INSTRUCTION SHEET

MARBLE HILL NUCLEAR GENERATING
STATION - UNITS 1 & 2
ENVIRONMENTAL REPORT - OPERATING LICENSE STAGE

SUPPLEMENT 2

VOLUNTARY REVISIONS

FIGURE 5.1-2

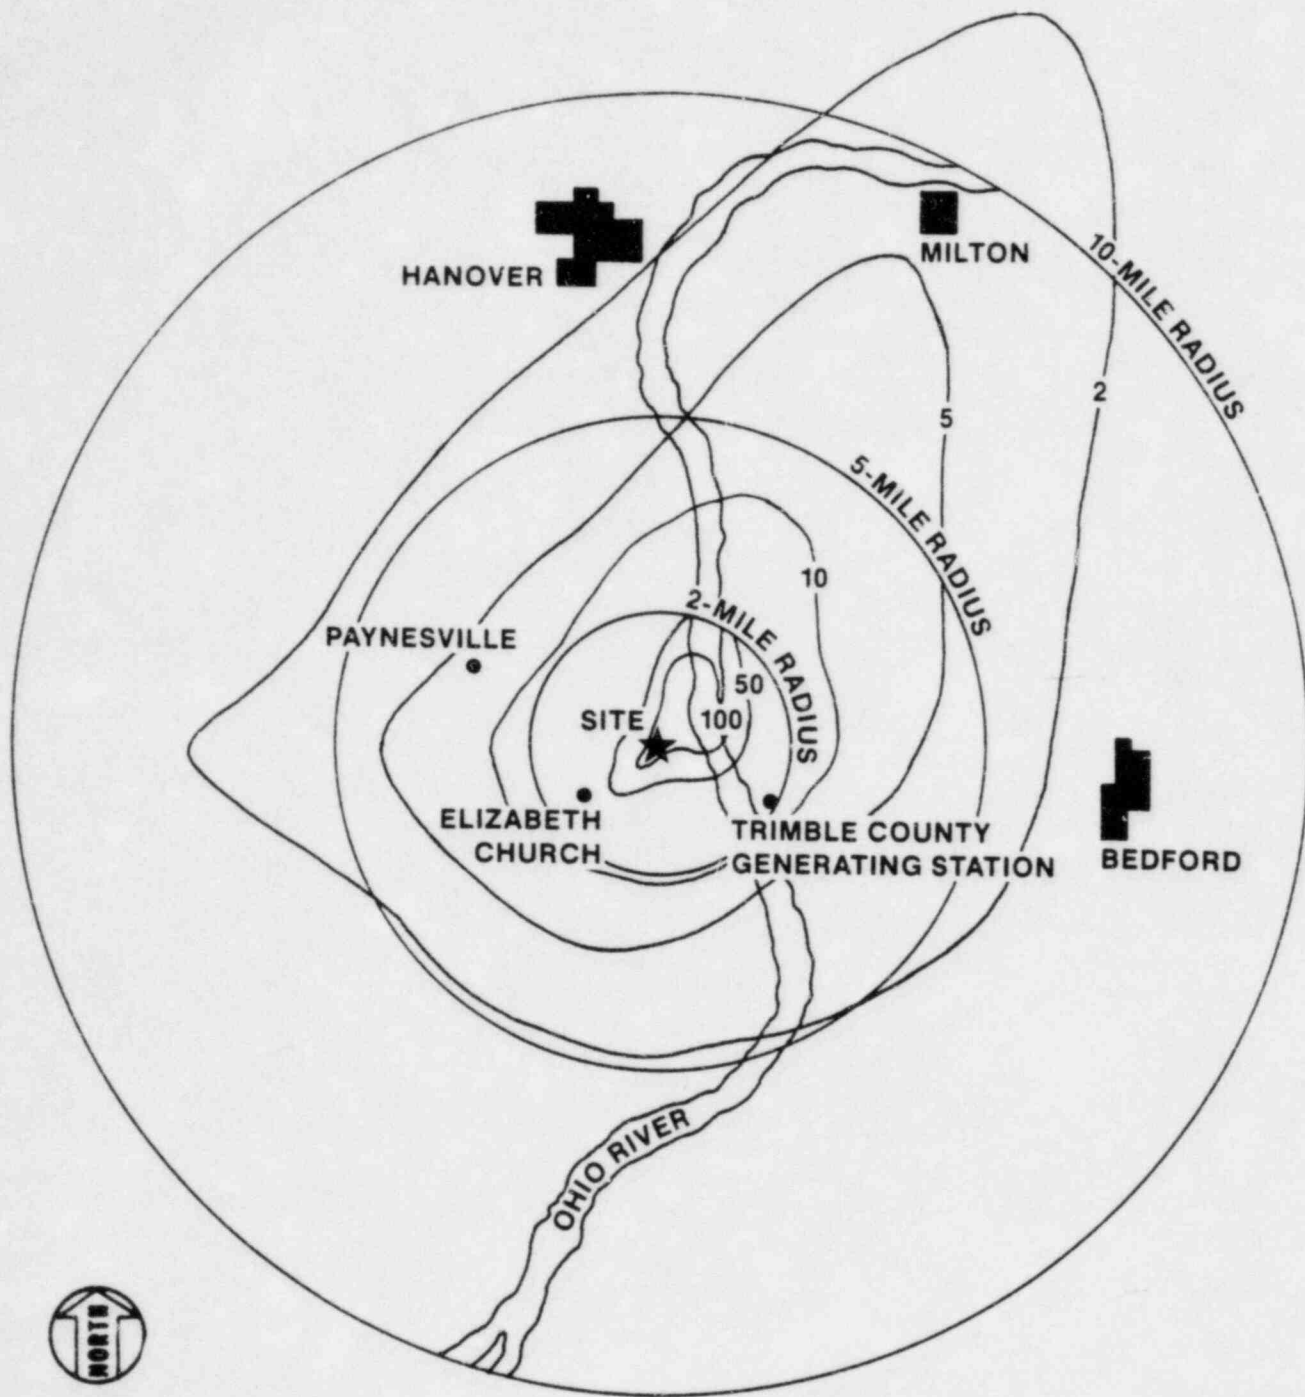
ER-OL Tables 5.1-6 through 5.1-9 and Figure 5.1-2 update the data presented in ER-CP Tables 5.1-14 through 5.1-18 and Figure 5.1-13 to take into account the lower drift rate, the higher TDS concentration, and the 1978-1979 meteorological data. All modeling results from the ER-CP have been scaled in accordance with these changes in cooling tower parameters and meteorological frequencies. It is assumed that the original drift droplet size distribution (see ER-CP Table 5.1-14) is applicable to the new drift rate. The distribution was originally derived as typical for modern mechanical draft cooling towers (see response to Question 102, Supplement 1 to the ER-CP). It is believed that the drift deposition data presented in ER-OL Tables 5.1-6 through 5.1-9 and Figure 5.1-2 are conservative, since the modeling assumed a 100% capacity factor and all drift emissions from a point source at the center of the cooling tower area.

Identify locations and acreages by crop type for agricultural lands within the salt drift isopleths of 50 and 100 kg/hectare/year depicted in Figure 5.1-2 of the ER-OL.

Why are the annual average drift deposition values shown in ER-OL Figure 5.1-2 higher than maximum values presented in the applicant's presentation in the FES-CP, page 5-8, given a reduction in drift rate from :0.02% of the flow to 0.008% of flow?

Maps depicting locations and acreages by crop type within the predicted 50 and 100 kg/hectare/year drift deposition isopleths were provided to the U.S. Nuclear Regulatory Commission on June 24, 1983. The 50 and 100 kg/hectare/year areas were derived from the revised drift deposition analysis described in the response to Question 290.7.

The drift deposition values cited in the FES-CP were extracted from the applicant's drift deposition analysis presented in Subsection 5.1.7.3.1 of the Marble Hill Environmental Report - Construction Permit Stage (ER-CP). The ER-CP and FES-CP both contain deposition values in English units (lb/acre-month). The FES-CP also contains the equivalent values in metric units (kg/hectare-month). A comparison of the metric values and English values on page 5-8 of the FES-CP indicates that the metric values should actually be approximately 6 times higher in order to correctly correspond to the English values. If the deposition values in lb/acre-month from the FES-CP are converted to kg/hectare-year and compared with the values shown in ER-OL Figure 5.1-2, the FES-CP values are found to be higher than the ER-OL values by a factor consistent with the change in the drift rate. This comparison is shown in Figure Q290.7-1. The change in the deposition is not uniform because different periods of meteorological data were used in the FES-CP and ER-OL analyses.

In responding to this question, it was discovered that the drift deposition analysis originally presented in the ER-OL was based on a total dissolved solids (TDS) concentration in the circulating water of 1500 mg/l. Although this concentration was the correct value at the Construction Permit stage, the TDS concentration in the circulating water is now expected to average 1635 mg/l (see ER-OL Tables 3.6-2 and 5.3-1). For consistency and conservatism, the drift deposition analysis has been revised using the higher TDS concentration. The revised values have been incorporated in Supplement 2 to ER-OL Subsection 5.1.4, which was provided to the U.S. Nuclear Regulatory Commission on June 24, 1983. As expected, the revised values are still generally lower than those presented at the Construction Permit stage and entail no significant change in environmental impacts from those originally presented in the ER-OL.
